## **MCMICHAEL FAMILY DIVISION SUBDIVISION**

APPLICATION NUMBER 19 DATE February 18, 2010

APPLICANT McMichael Family Division Subdivision

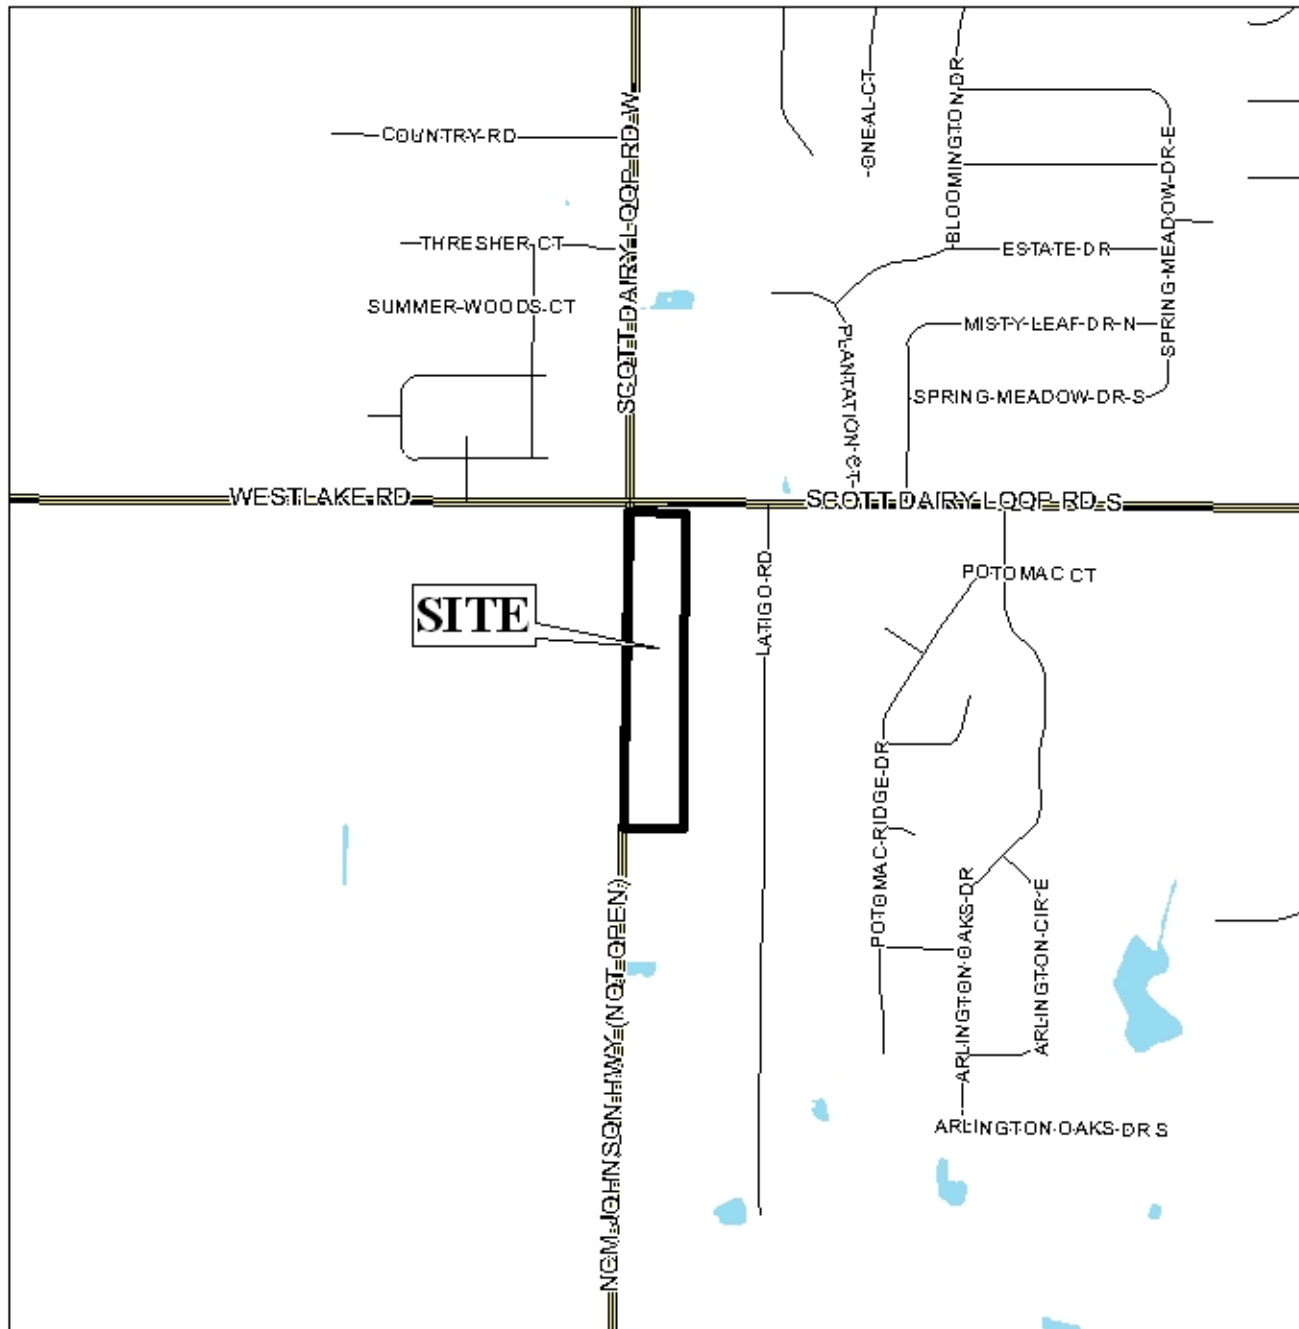
There are several issues of concern with this proposed plat. Firstly, it should be mentioned that the site fronts Scott Dairy Loop Road South to North, and Johnson Highway (unopened public right-of-way). Both Scott Dairy Loop Road South and Johnson Highway are major streets listed on the Major Street Plan Component of the Comprehensive Plan, and both require 100-foot wide rights-of-way. Dedication sufficient to provide 50 feet from the centerline of each major street right-of-way will be required, and, as such, dedication for this property may be necessary.

Secondly, the proposed subdivision consists of a rectangular lot, a flag lot with a 95-foot wide flagpole (with the 25-foot minimum building line behind where the lot opens up to 275 feet in width), and another flag lot with a 25-foot wide flagpole (with the 25-foot minimum building line behind where the lot opens up to 300 feet in width). There are no flag lots in the immediate vicinity of this site. GIS mapping shows the nearest flag lot to be almost one mile from the subject property. Further, the flag lots are being created to maintain frontage along Scott Dairy

Loop Road South, when the structures that are already there are accessing public right-of-way via a 10-foot wide privately maintained gravel drive built onto the public Johnson Highway right-of-way. With that being stated, the site does not appear to comply with Section V.D.1 of the Subdivision Regulations in that flag lots are not generally compatible with the existing development in the area, and that the two flag lots appear to be proposed in lieu of improving Johnson Highway to County Paved-Road Standards.

Further, as dedication of up to 20 feet will likely be required for the Johnson Highway right-of-way, the 25-foot wide flagpole portion of the proposed Lot 3 would be almost completely eliminated. If that happened, the proposed Lot 2 would also have to be reconfigured in order to accommodate the changes for the proposed Lot 3.

Also, given that the intersection of Scott Dairy Loop Road South and Johnson Highway is a proposed major street intersection; having two accessways for flag lots meeting at a major intersection would possibly present a traffic hazard.

Finally, it should be noted that the applicant did not provide any justification for a flag lot.

- 1) the site does not comply with Section V.D.1 of the Subdivision Regulations regarding flag lots.
